DEPARTMENT OF TRANSPORTATION

July 7, 2022

> RE: Preliminary Plan No. 120220010 Miles Coppola Preliminary Plan & Traffic Impact Study Letter

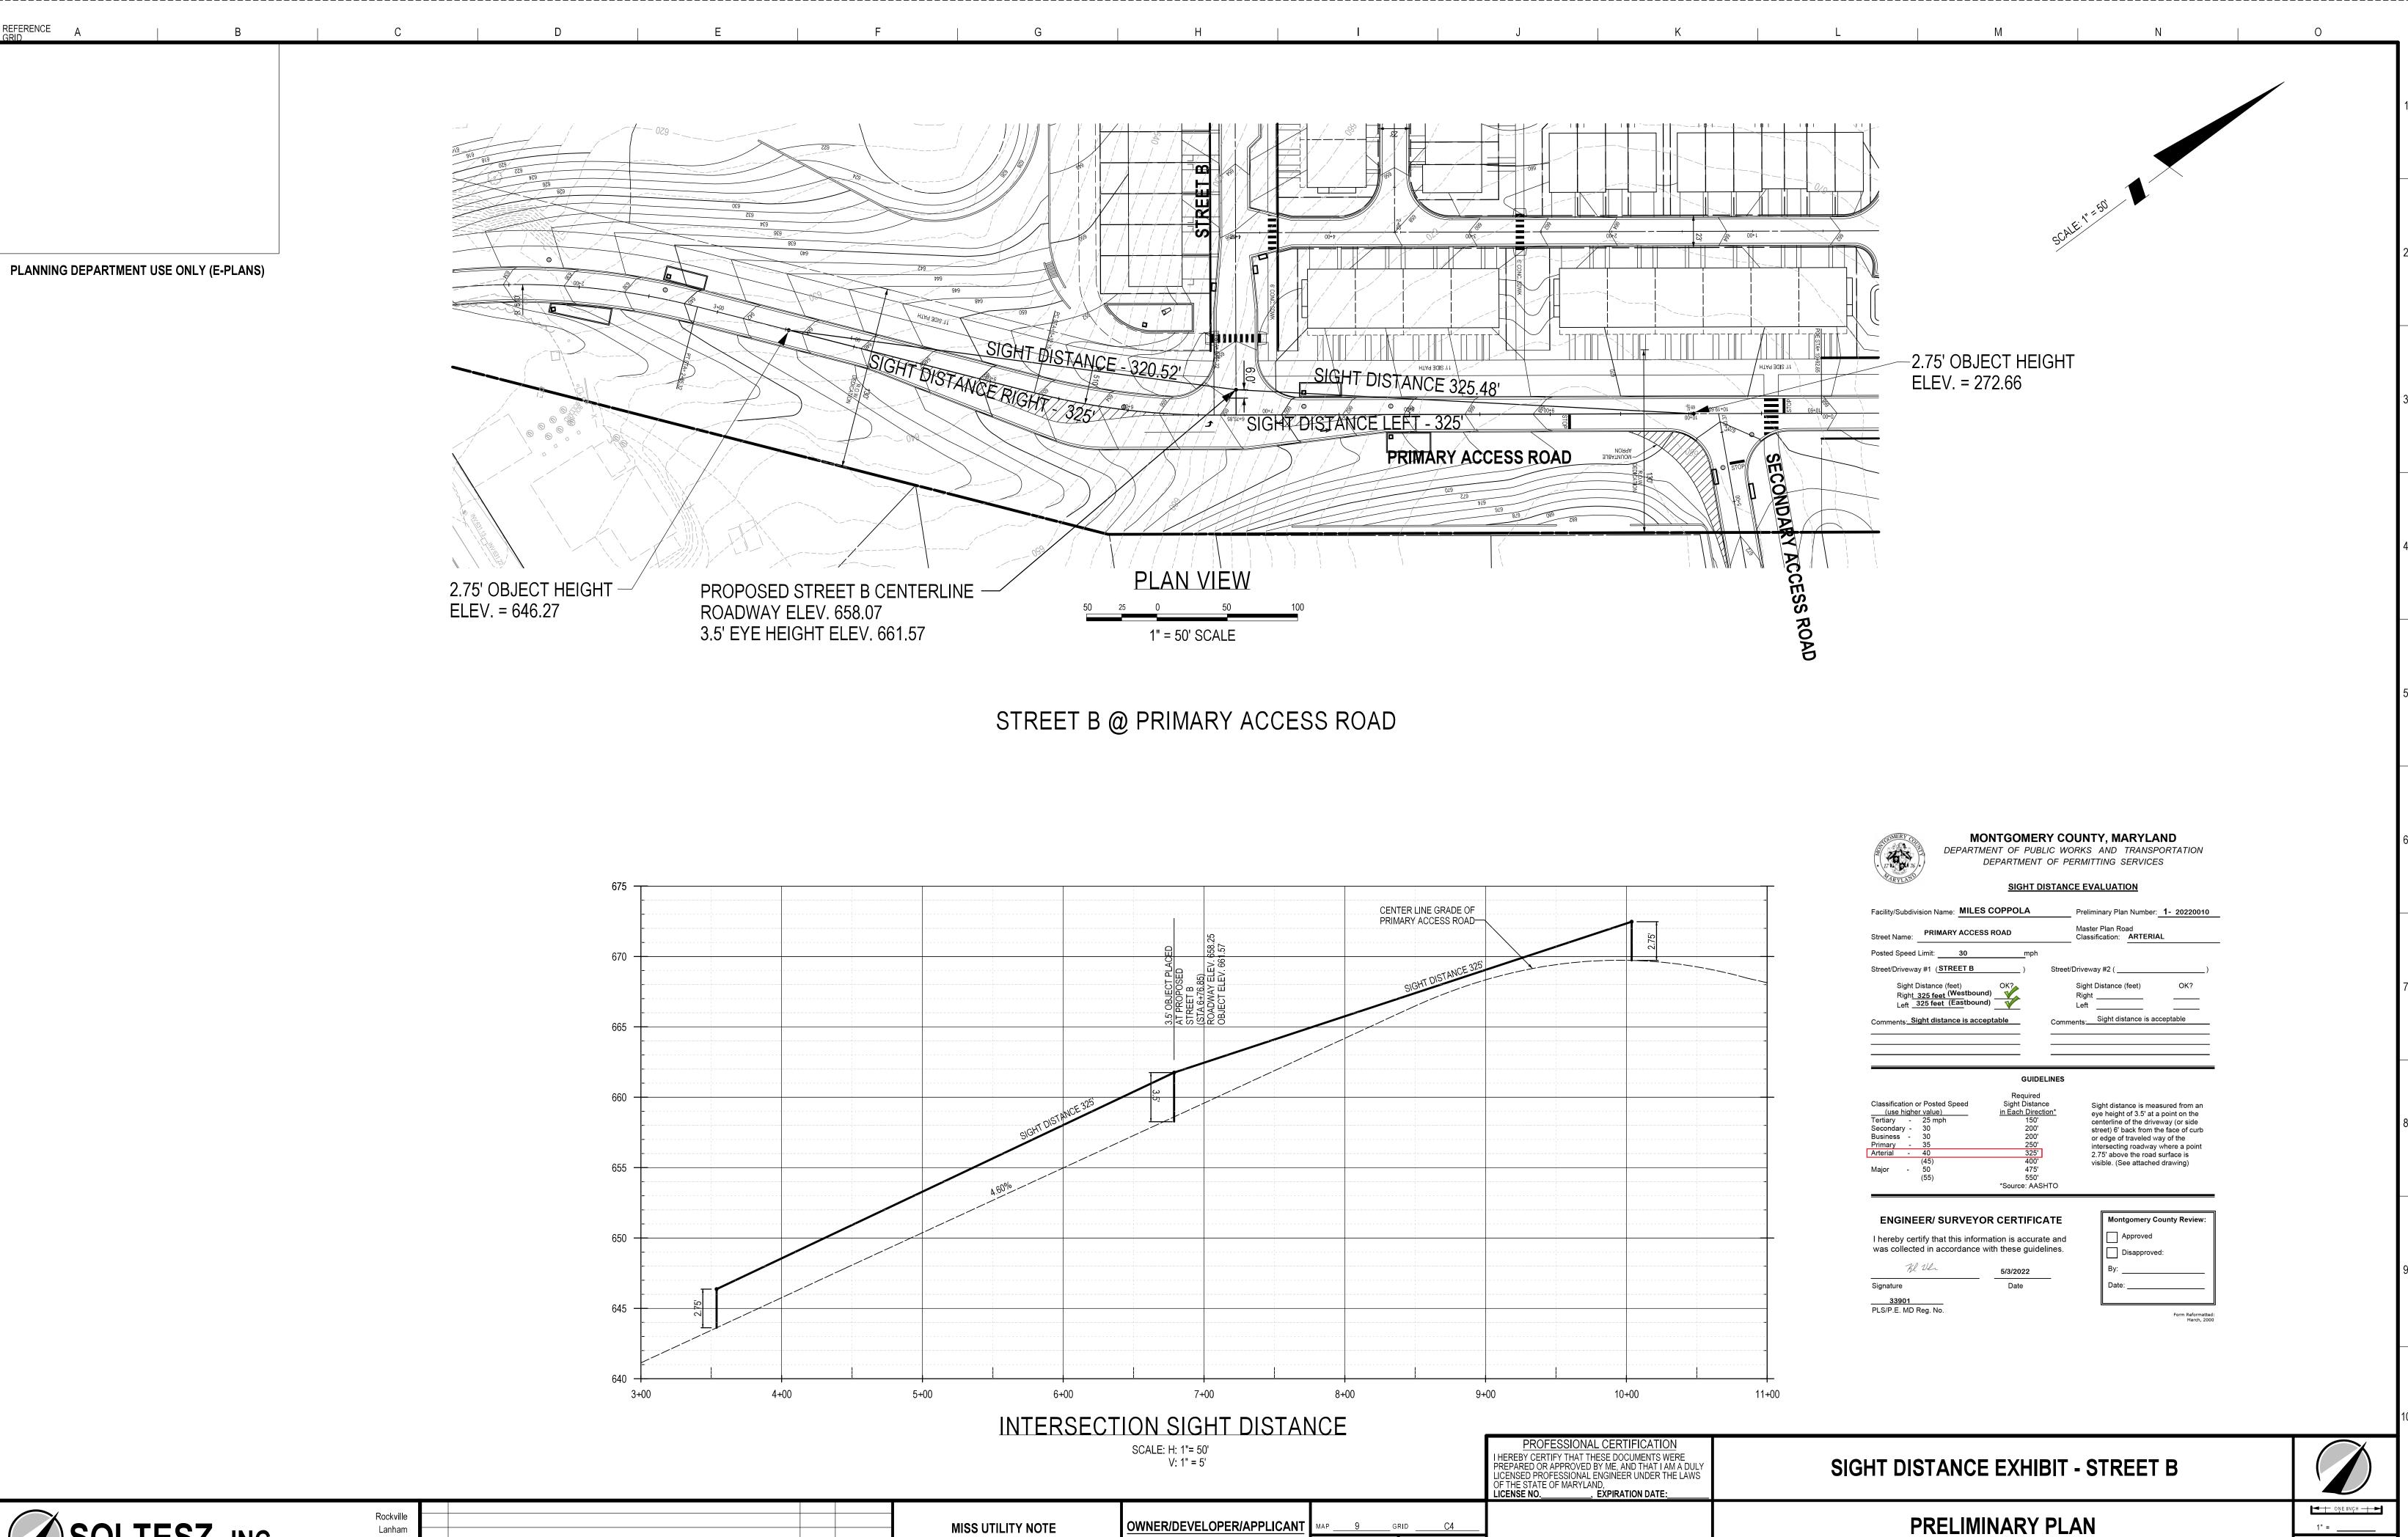
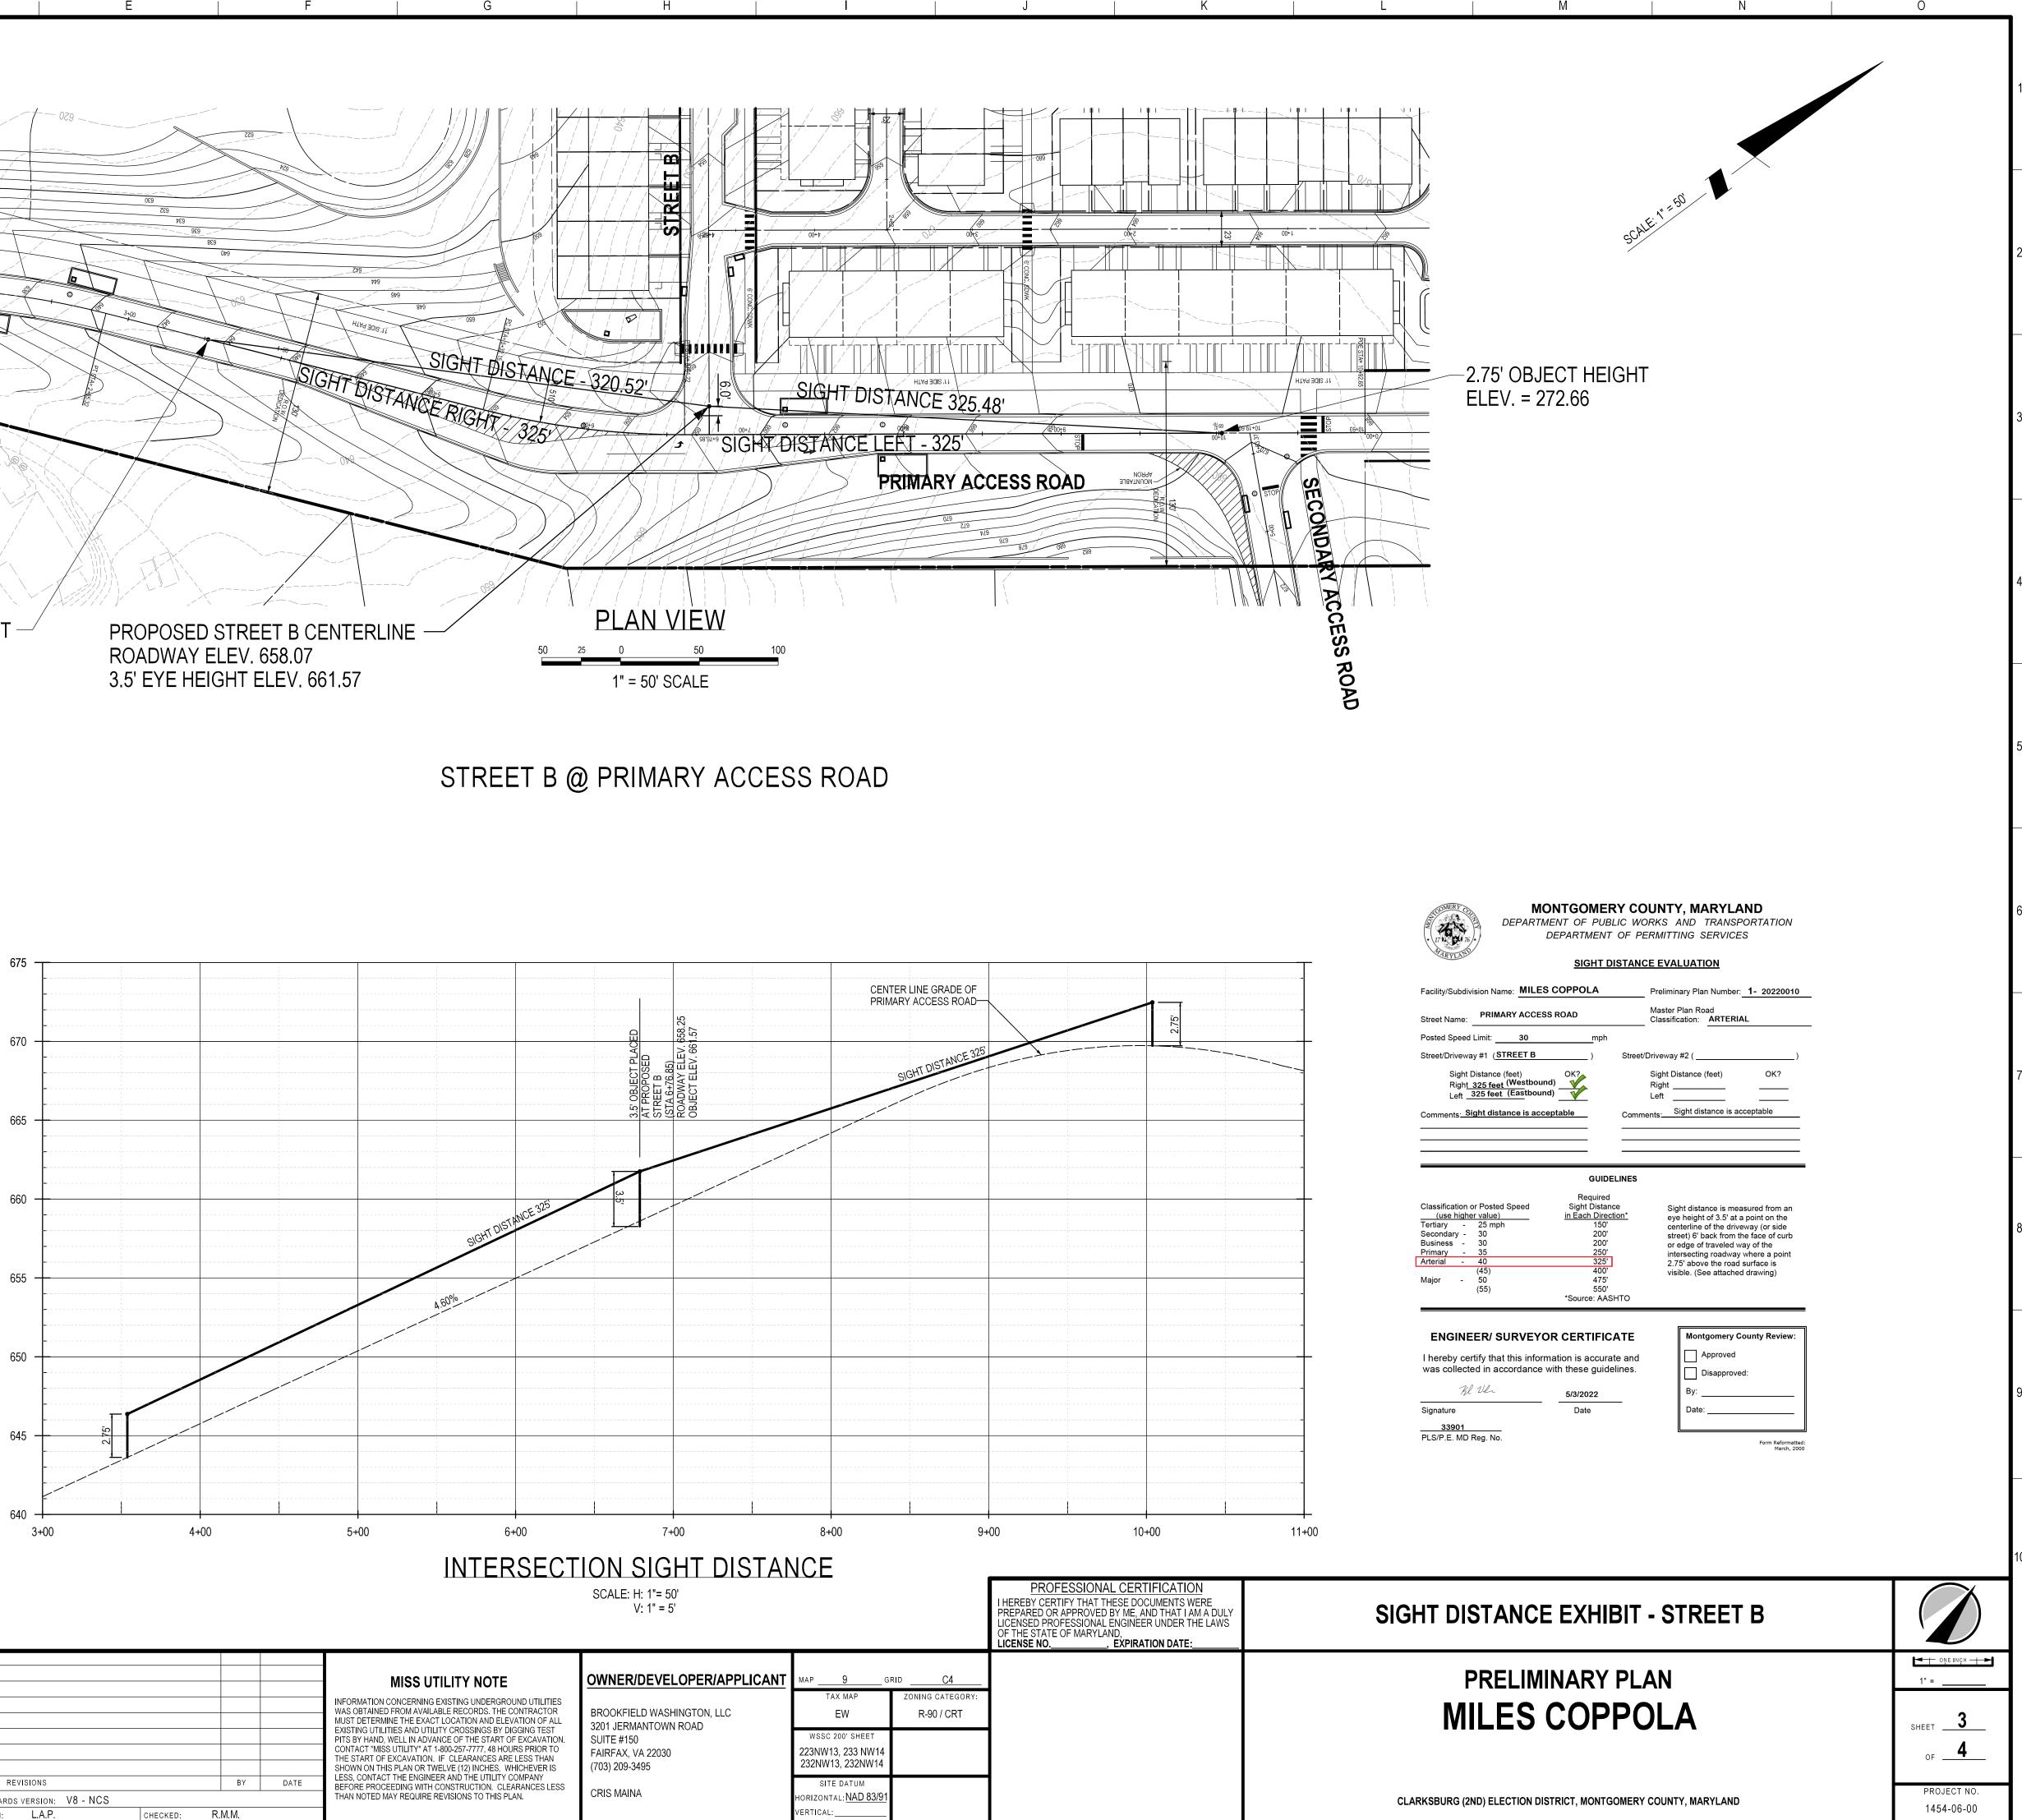
Facility/Subdivision Name: MILES COPPOLA	Preliminary Plan Number: 1- 20220010
Street Name: PRIMARY ACCESS ROAD	Master Plan Road Classification: ARTERIAL
Posted Speed Limit:30mph	
Street/Driveway #1 (STREET B)	Street/Driveway #2 ()
Sight Distance (feet) OK? Right <u>325 feet (Westbound)</u> Left <u>325 feet (Eastbound)</u>	Sight Distance (feet)OK?RightLeft
Comments: Sight distance is acceptable	Comments: Sight distance is acceptable

Montgomery County Review:						
Approved						
Disapproved:						
By: Brenda M. Pardo						
Date: 6/7/22
